Difference description

Model No.(EUT):T8

FCC ID: 2AUOUT8

Material change list :

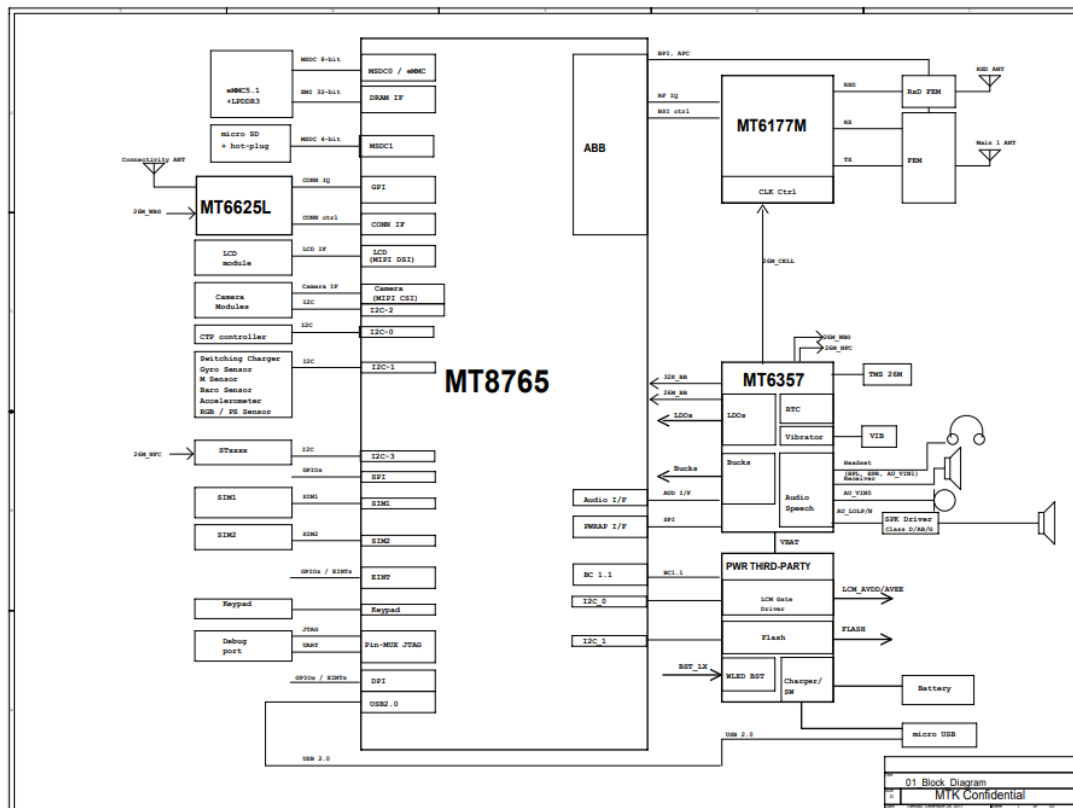
Change request					
Involved to change the model	AS8E2H2WH2FF90HD8091000, AS8E2H2WH2FF90HD8091002	Before the change	U5003=YL19-012109-0001/RF TIP2109BTM5T62/Triplexer for GPS&WIFI(2.4G/1.57G/5G)	After the change	The replacement material is: U5003=YL19-01450G-0001/SLFT21-2R450G-02T/Triplexer for GPS&WIFI (2.4G/1.57G/5G) The
			U3418=YL20-008680-0001/MXD8680/SP8T		replacement material is: U3418=YL20-001618-0002/VC1618A/SP8T Switch
			U3916=YL20-007916-0006/VC7916-51/GSM/GPRS/EDGE /TD-SCDMA/TD-LTE 4-segment RF power amplifier and 16T antenna switch Encapsulation QFN38 5.5mmX5.3mmX0.83mm		U3916=YL20- 007916-0008/VC7916-51-1/GSM/GPRS/EDGE/TD-SCDMA/TD-LTE 4-segment RF power amplifier and 16T antenna switch Encapsulation QFN38 5.5mmX5.3mmX0.83mm
			U4201=YL20-0432G0-0038/MEMA032G-M0S00/EMMC, 5.1, 32GB, TLC, 11.5mm x 13mm x 1mm, BGA153		U4201=YL20-04F32G-0003/MEMA032G-M0D01/EMMC, 5.1/HS400, 32GB, TLC, 1.8/3.2V, BGA153

1.U3916=VC7916-51 main function: GSM/GPRS/EDGE RF power amplifier and 16T antenna switch

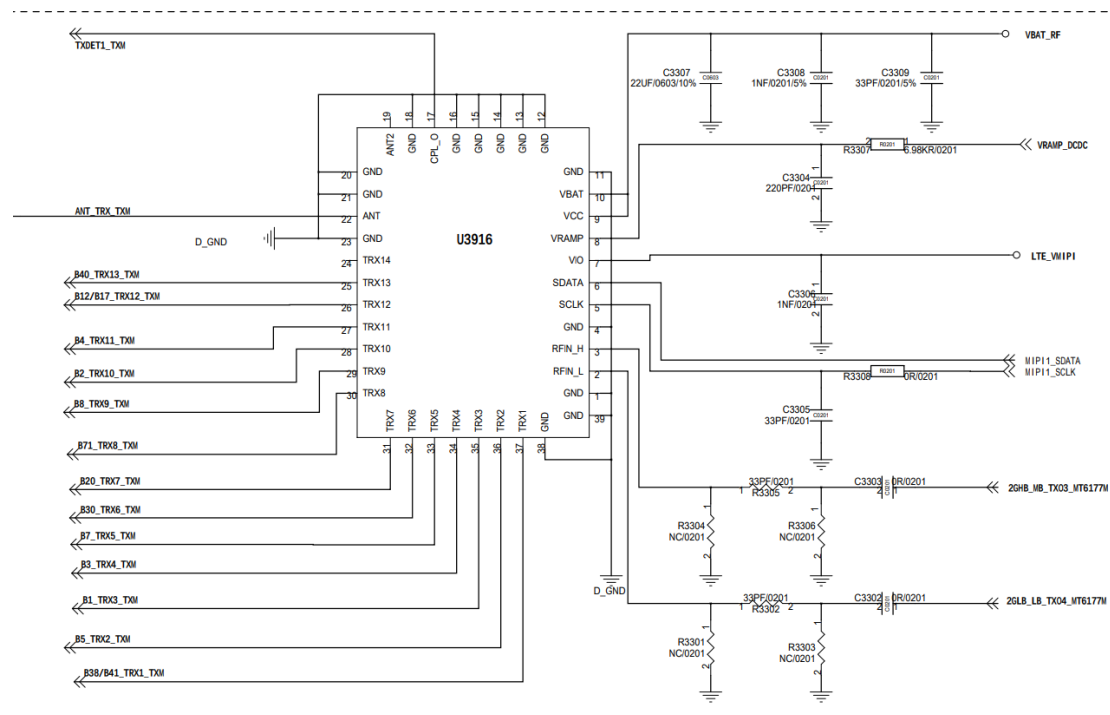
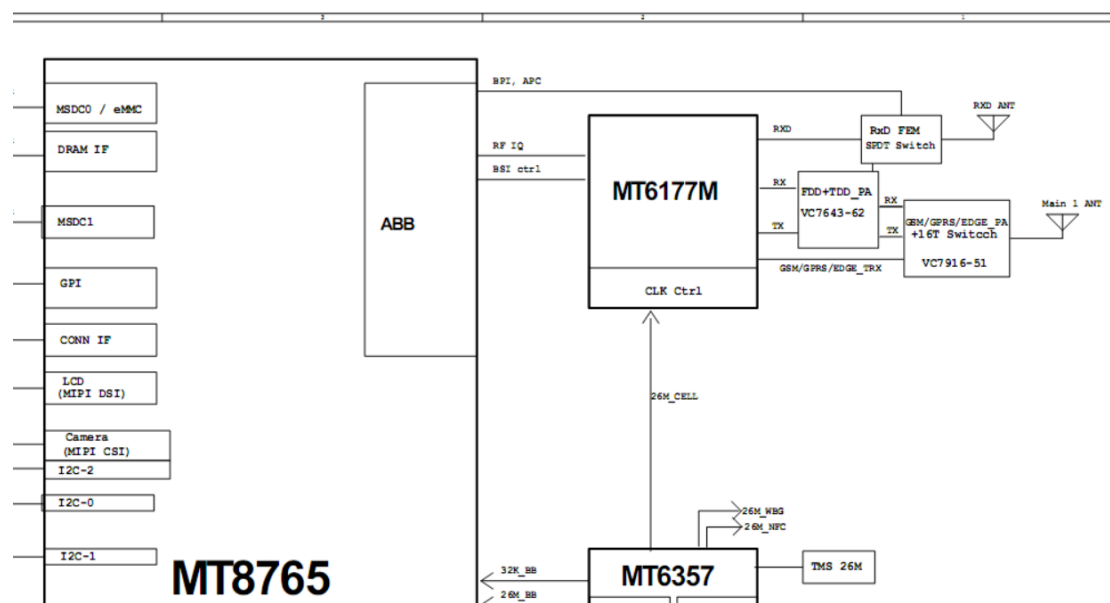
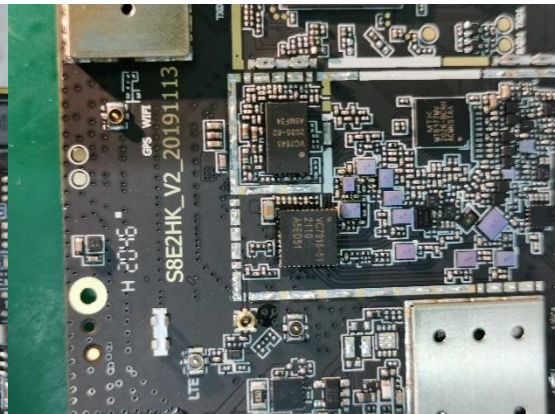
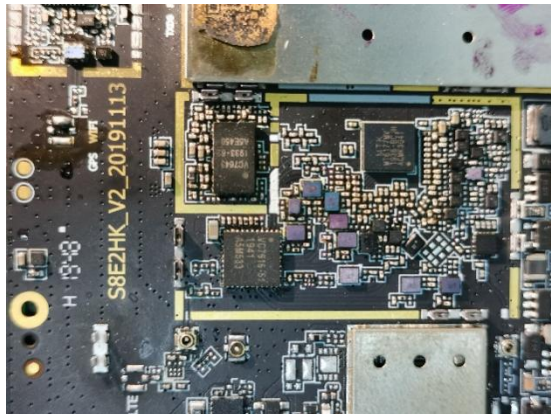
Different batches of PA (VC7916-51) have been replaced.

Different batches refer to substrates supplied by different substrate suppliers at different times, and PA produced and processed by different processing plants. There are no other differences.

The PA PIN before replacement is the same as the PA PIN after replacement, there is no change.

2, U3916=SLFT21-2R450G-02T Triplexer for GPS&WIFI (2.4G/1.57G/5G) Main function: 2.4G/1.57G/5G power splitter

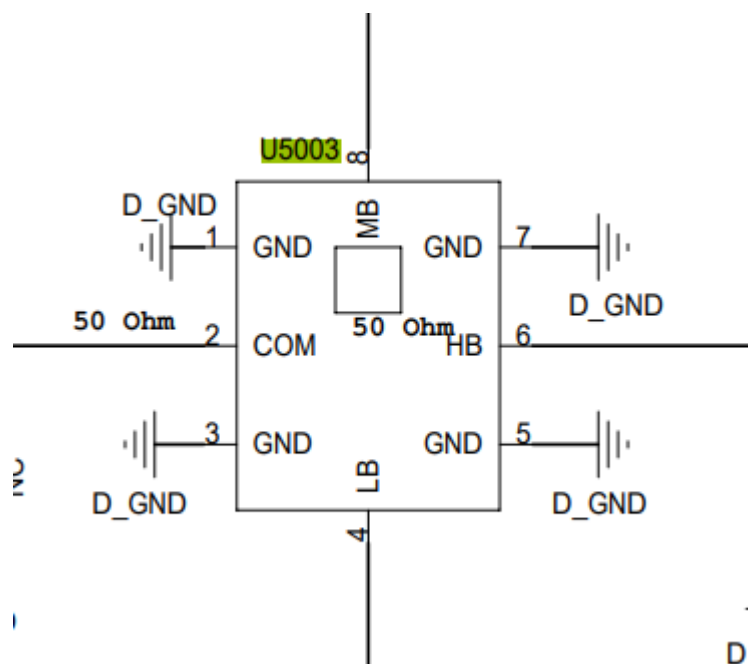
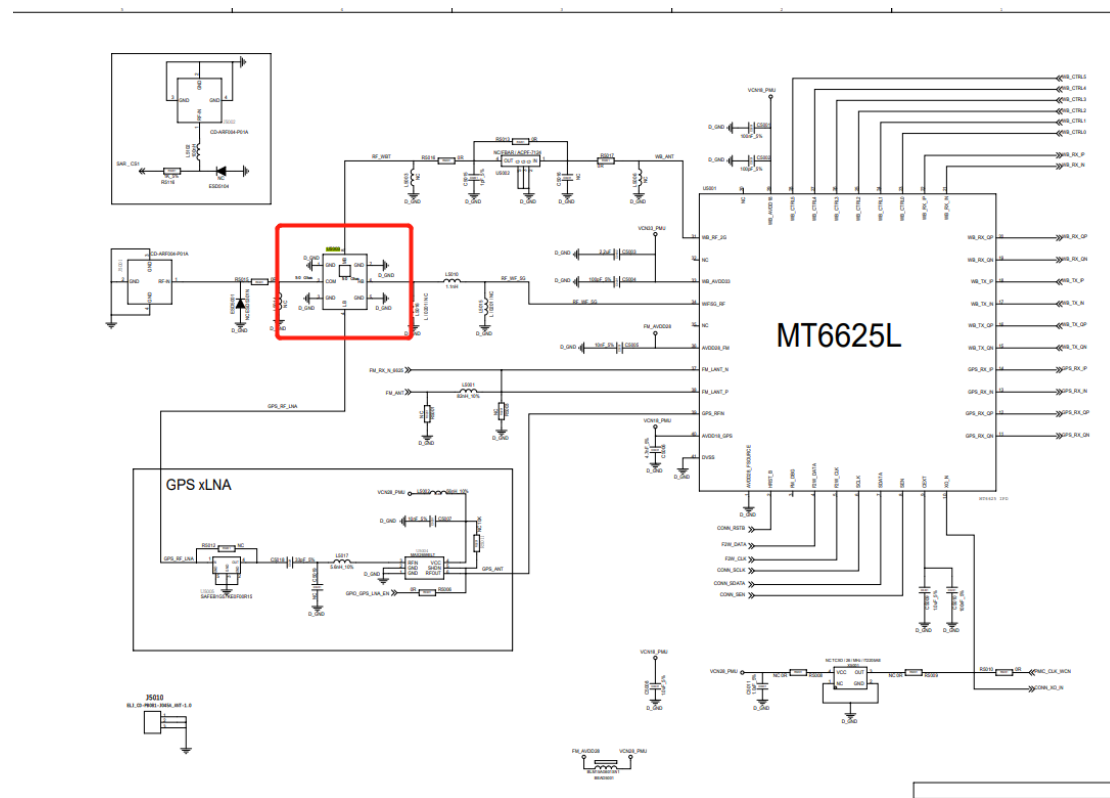
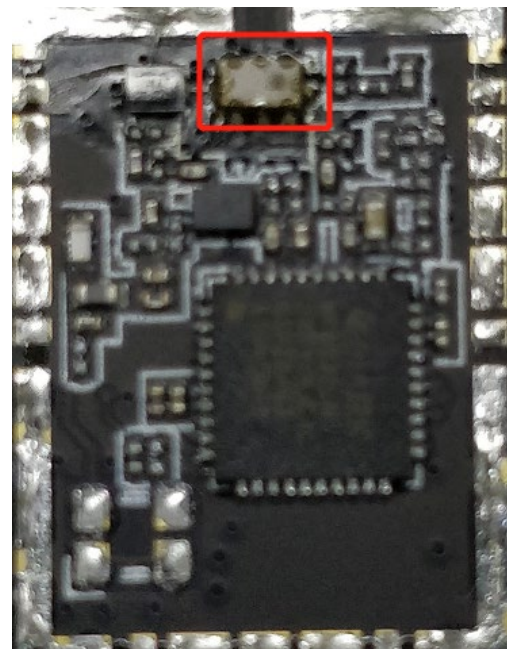
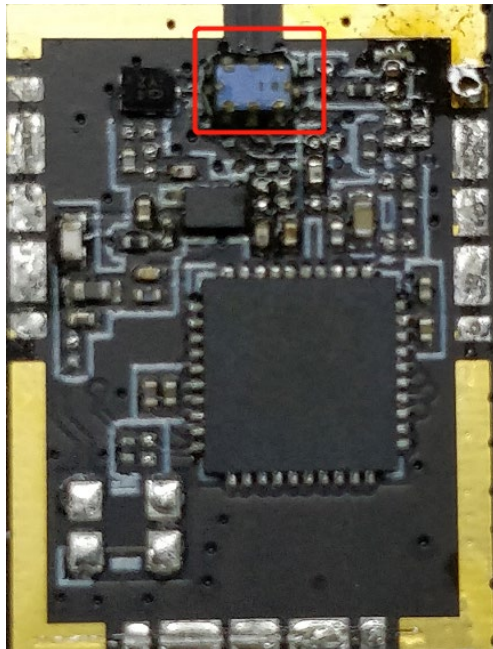
Due to market supply, the purchase of different batches refers to the power dividers produced and processed by different processing plants at different times, supplied by different suppliers. There are no other differences.

The PA PIN before replacement is the same as the PA PIN after replacement, there is no change

3. U3418=VC1618A SP8T Switch main function: WCDMA/LTE diversity receiving antenna switch

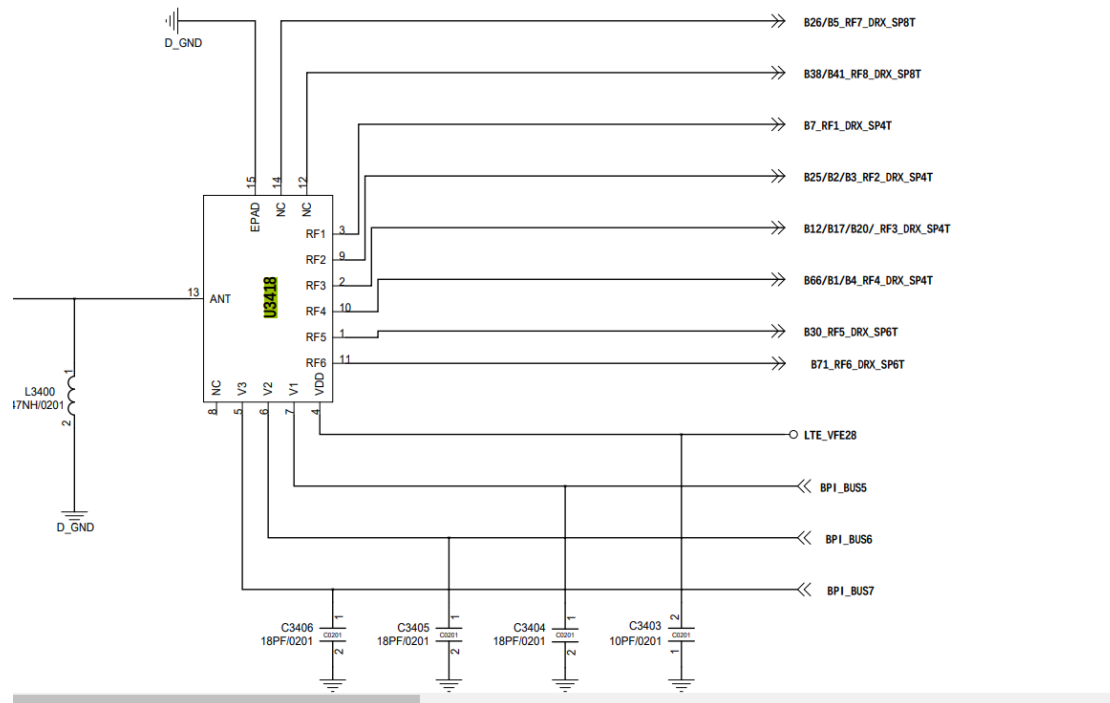
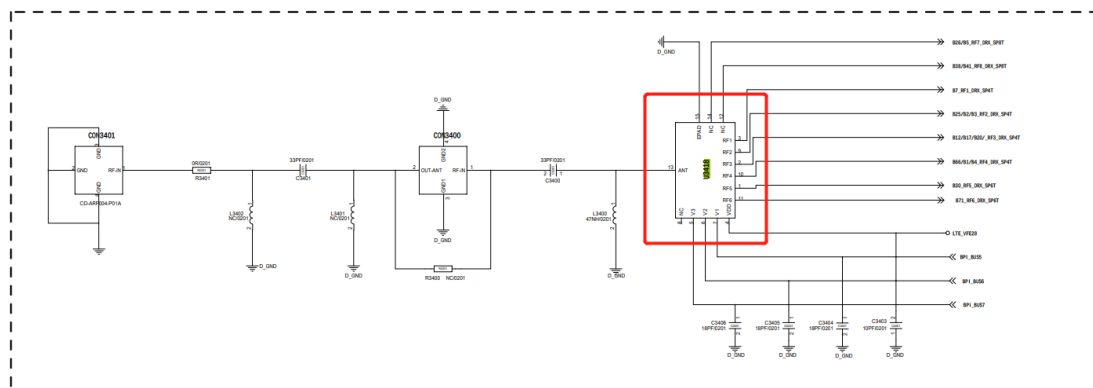
Due to market supply, different batches of purchase refer to products supplied by different suppliers at different times, and produced and processed by different processing plants. There

are no other differences.

The PA PIN before replacement is the same as the PA PIN after replacement, there is no change
